SUBJECT: James A. FitzPatrick Nuclear Power Plant
Docket No. 50-333
**Request for Additional Information -
Proposed Changes to the Technical Specifications
Spent Fuel Pool Storage Capacity (JPTS 90-035)**

**RESPONSE TO NRC REQUEST 2 FOR ADDITIONAL INFORMATION
SPENT FUEL POOL STORAGE CAPACITY INCREASE**

HOLTEC REPORT HI-91614
DYNARACK SIMULATIONS TO DEMONSTRATE THE ABILITY
TO PREDICT CLASSICAL NONLINEAR PHENOMENA

FIGURE 1

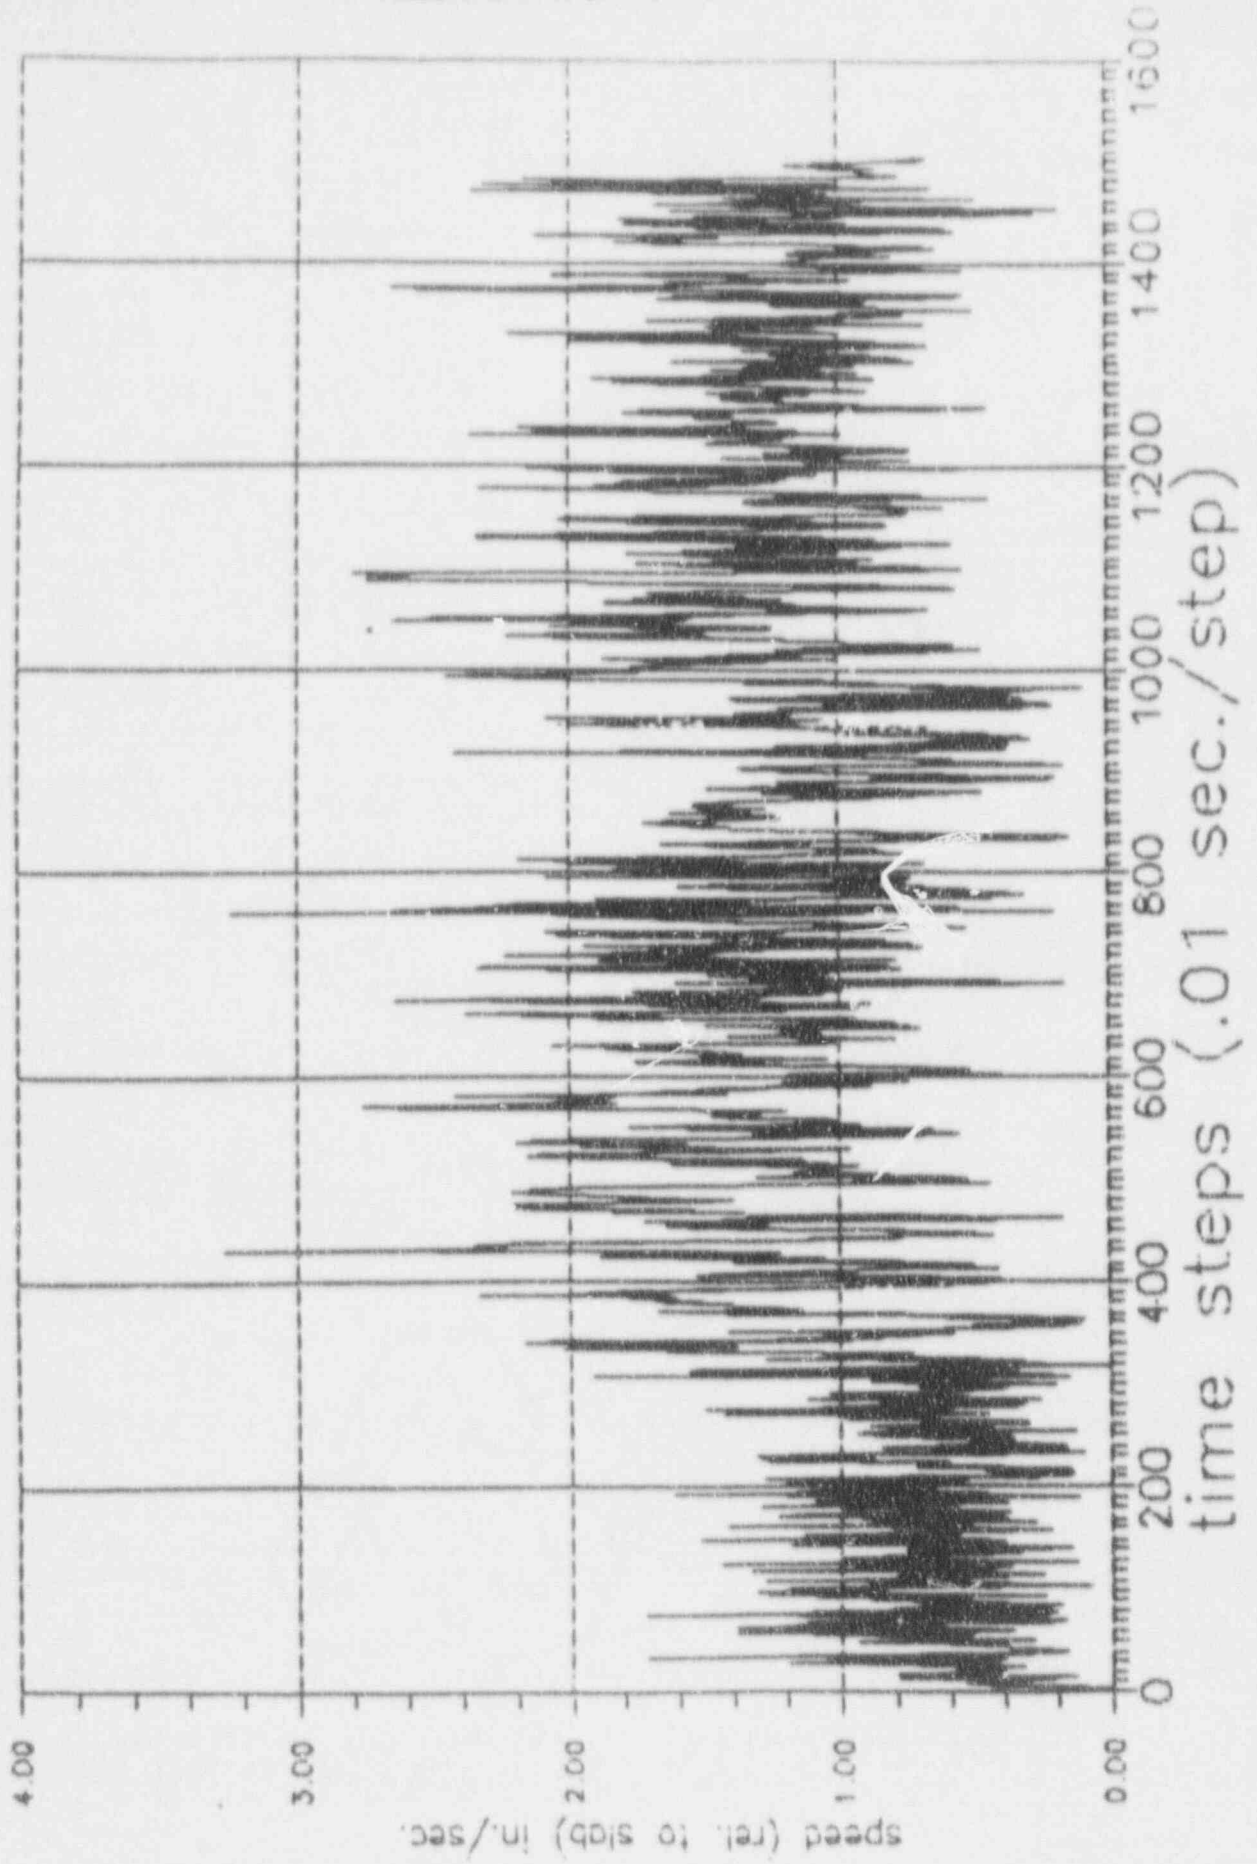
NRC Question 1 P. 6-4. It is stated that "lift off of the support legs and subsequent liner impacts must be modelled using appropriate impact (gap) elements, and Coulomb friction between the rack and the pool liner must be simulated by appropriate precise [sic] linear springs."

Discuss, with specific examples, how one simulates Coulomb friction by appropriate piecewise linear springs. Demonstrate that such model does simulate actual physical responses by means of experimental data or analytical solutions. Provide a discussion of mathematical basis of such model which was utilized in your computer program and provide a simple calculation whereby one can compare with a closed form solution or an alternate numerical approach to establish the validity of your solution.

Supplement to NRC Question 1 During a phone conversation, the NRC agreed that the Authority could show that the relative sliding velocity between the rack pedestal and pool liner is "low" enough so that a constant coefficient of friction may be used, instead of responding to the third part of NRC Question 1.

To determine the relative sliding velocity at the pedestal-liner interface, the Authority reviewed the results of one of the DYNARACK simulations. Specifically, the Authority examined the results from an analysis of the B rack (11x12). The net horizontal velocity of the pedestal base, relative to the floor was calculated as a function of time.

Figure 1 provides a plot of the net velocity V defined as:

where VX, VY are the instantaneous velocity in the X and Y directions, respectively. Figure 1 shows that $V_{\max} \approx 3.3$ in./sec, which the Authority considers "low". For such a "low" velocity, the variation in coefficient of friction will not be significant.

Figure 2

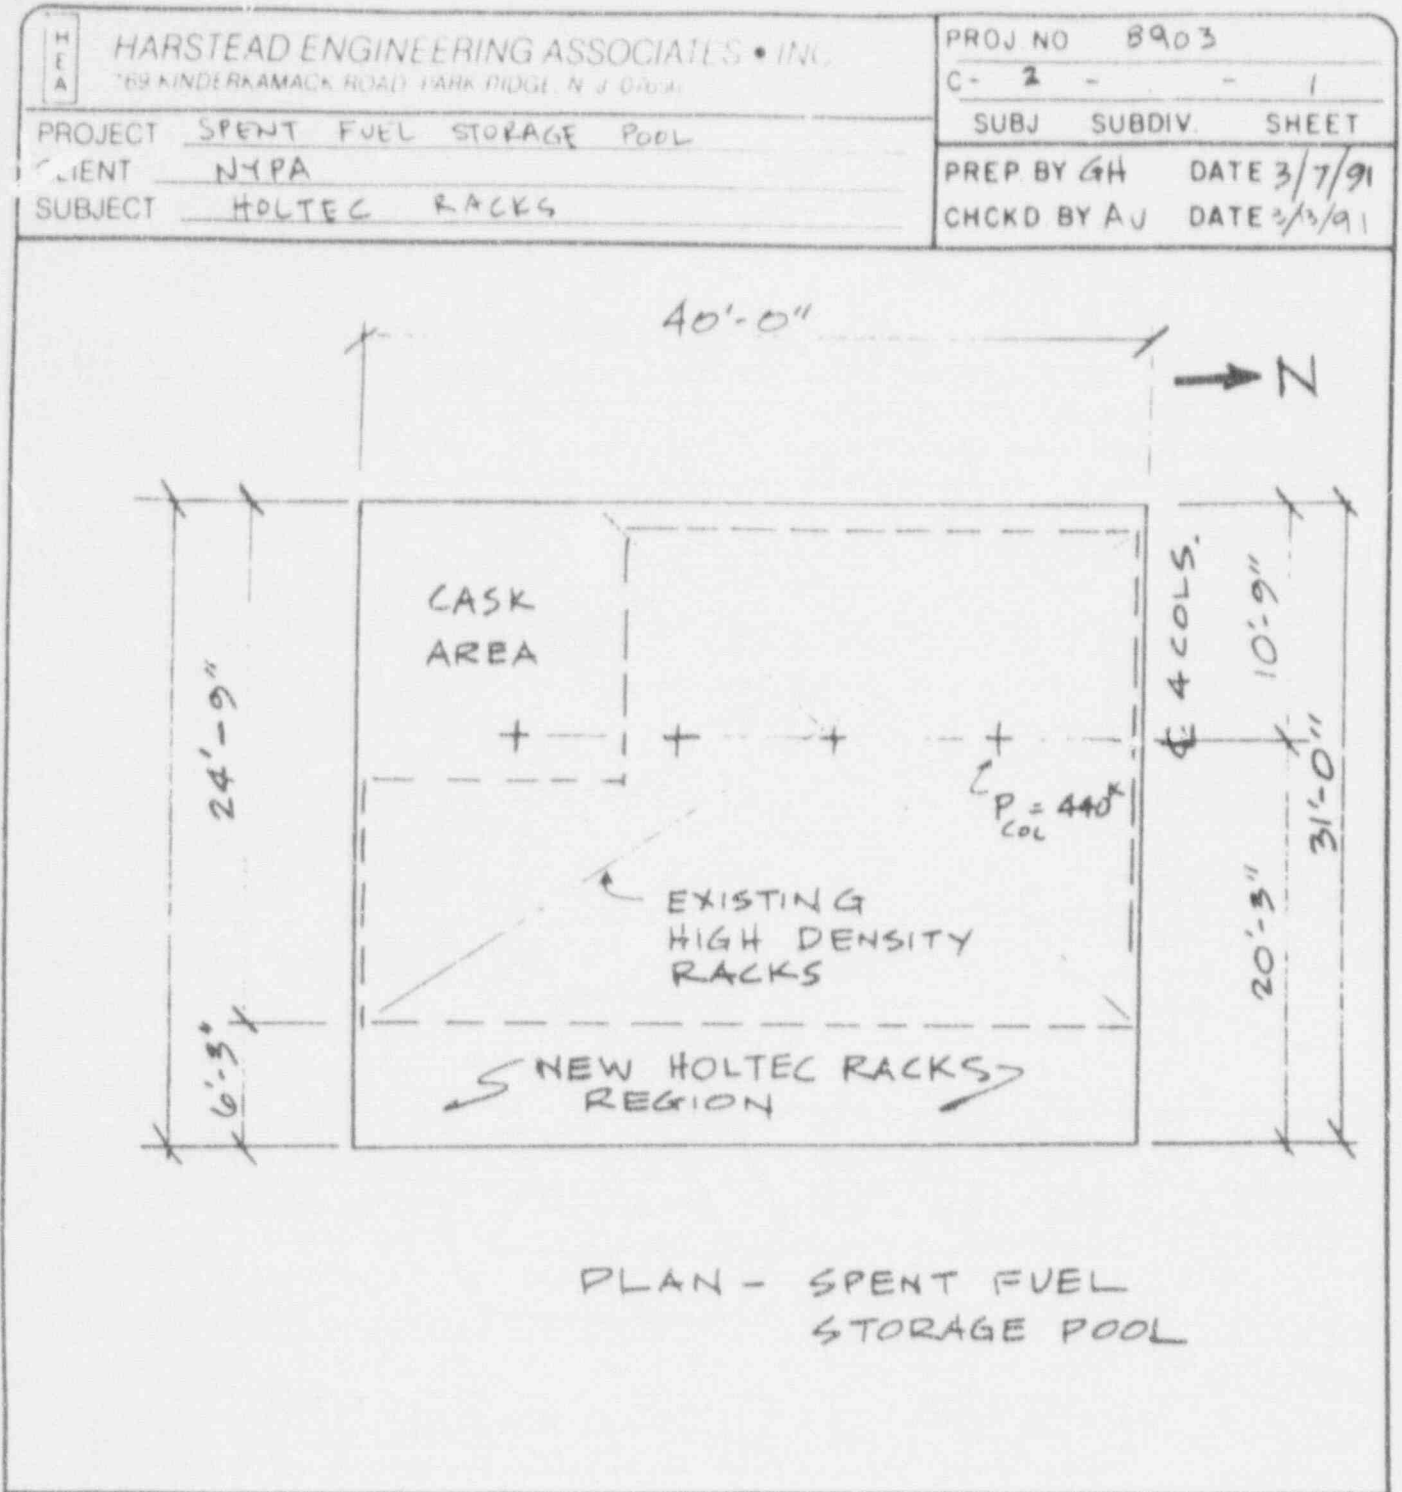
NRC Question 5 P. 9-1. Provide key stresses (or strength) and applicable margins that correspond to each load combination. Provide an estimate of the potential increase in stress (decrease in margin) if the current load is calculated using non-linear limit strength analysis. Also provide approximate increase in loads from current to proposed maximum loads for the pool structure.

Supplement to NRC Question 5 During a phone conversation, the NRC requested information about the spent fuel pool dimensions.

Spent Fuel Pool Dimensions

The dimensions of the pool slab are 31' - 0" wide x 40' - 0" long x 5' - 0" thick. The slab is supported by four additional steel columns located 10' - 9" from the west wall. These columns are 24" in diameter with Belleville springs at the base. Each column was designed to provide a constant upward force of approximately 440 kips on the slab. These columns were added when the original racks were replaced with high density racks. Figure 2 provides a schematic of the spent fuel storage pool.

FIGURE 2.3

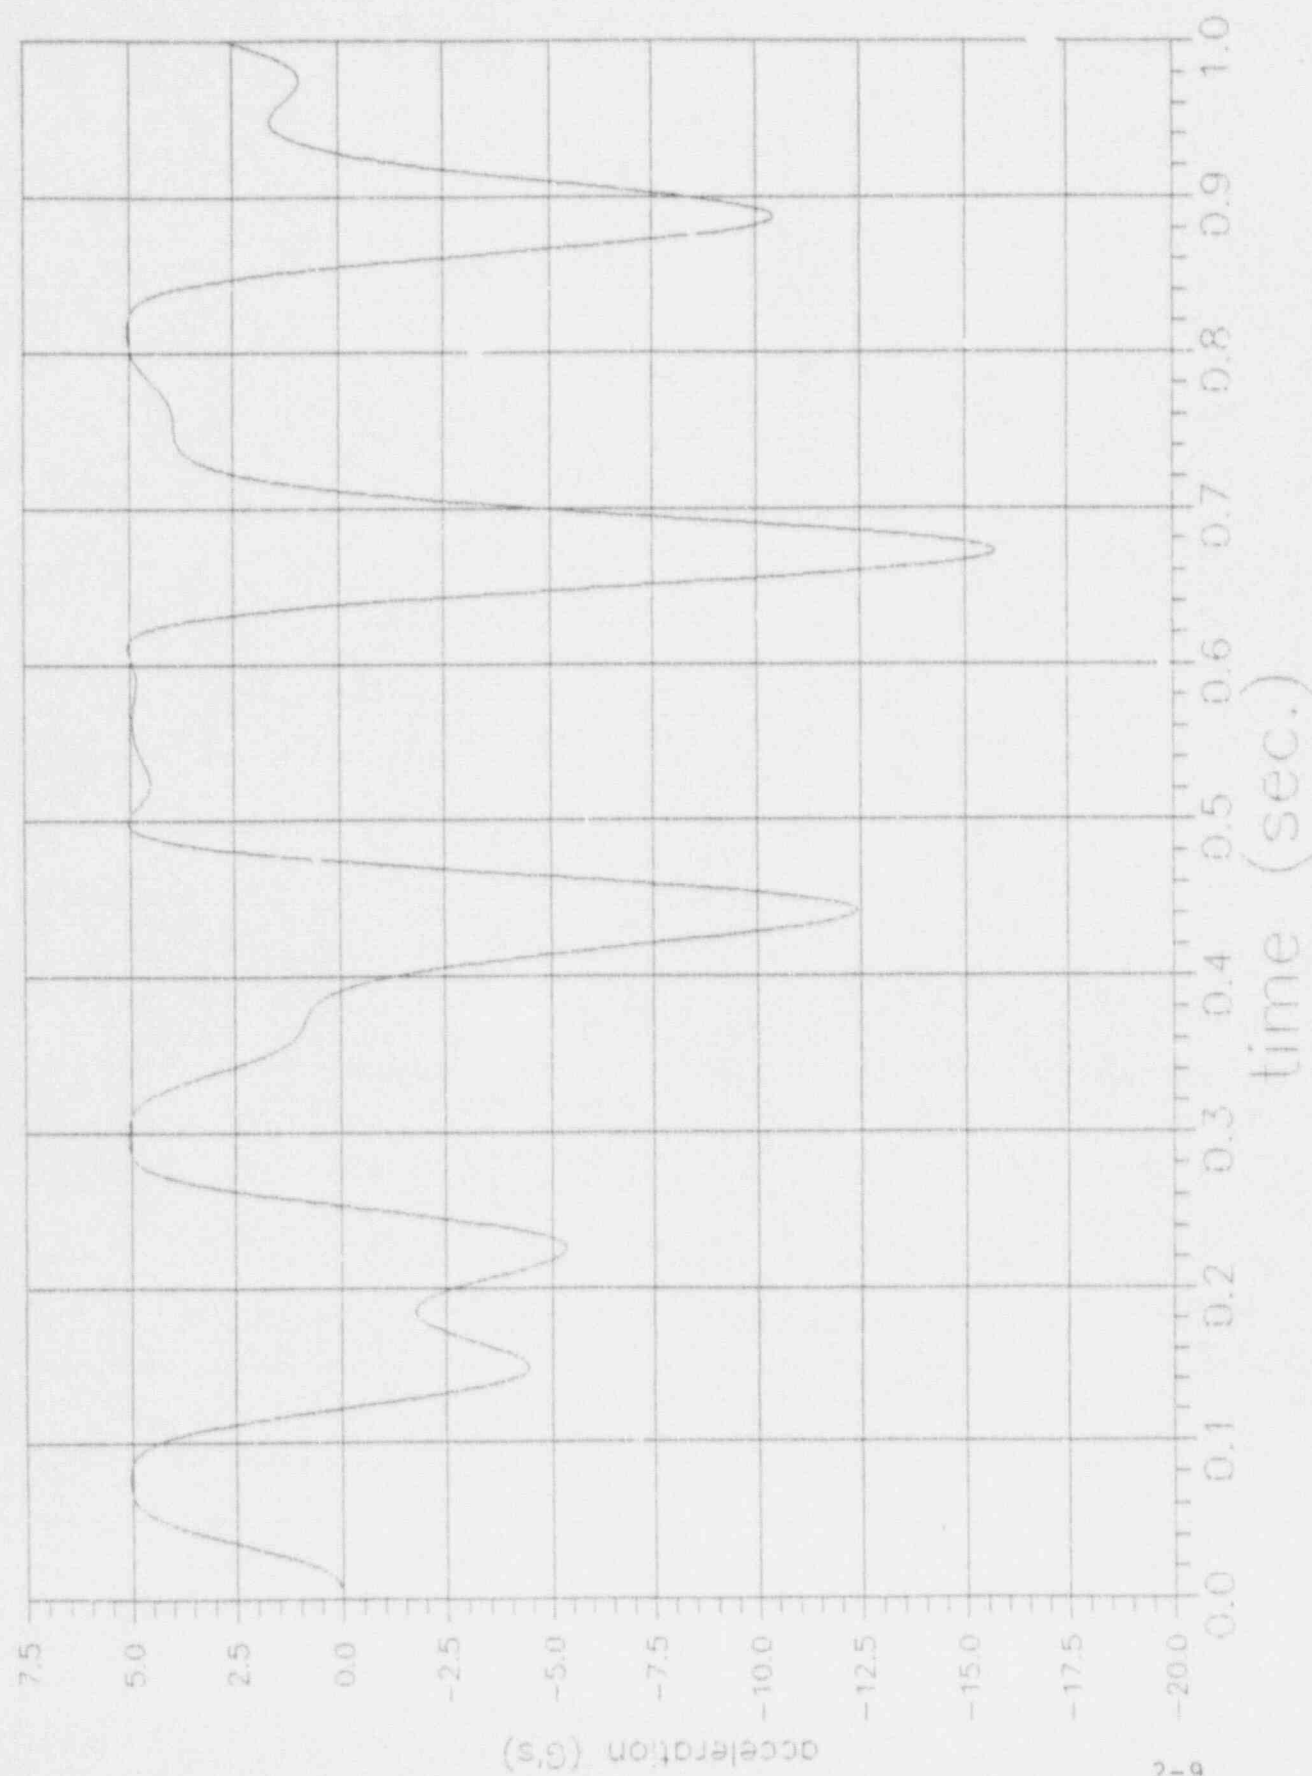
P. 6-15. It is stated that a central difference scheme is used for solution of the governing differential equations. Demonstrate how such a scheme can adequately depict various response phenomena, such as, subharmonic, bifurcation, and instability associated with nonlinear dynamics. Provide a specific example for such demonstration similar to that provided in references (1) and (2). Discuss how error associated with numerical integration is assessed and accounted for in a similar manner as that of reference (3). Also provide verification of the computer results with available experimental data.

Figure 2.3 shows the acceleration of the mass versus time. The subharmonic resonance is clearly visible in that there is a strong response at 4.7 HZ (half the frequency of the imposed driving excitation). Appendix A contains numerical results for the same problem done in Reference 6.6.
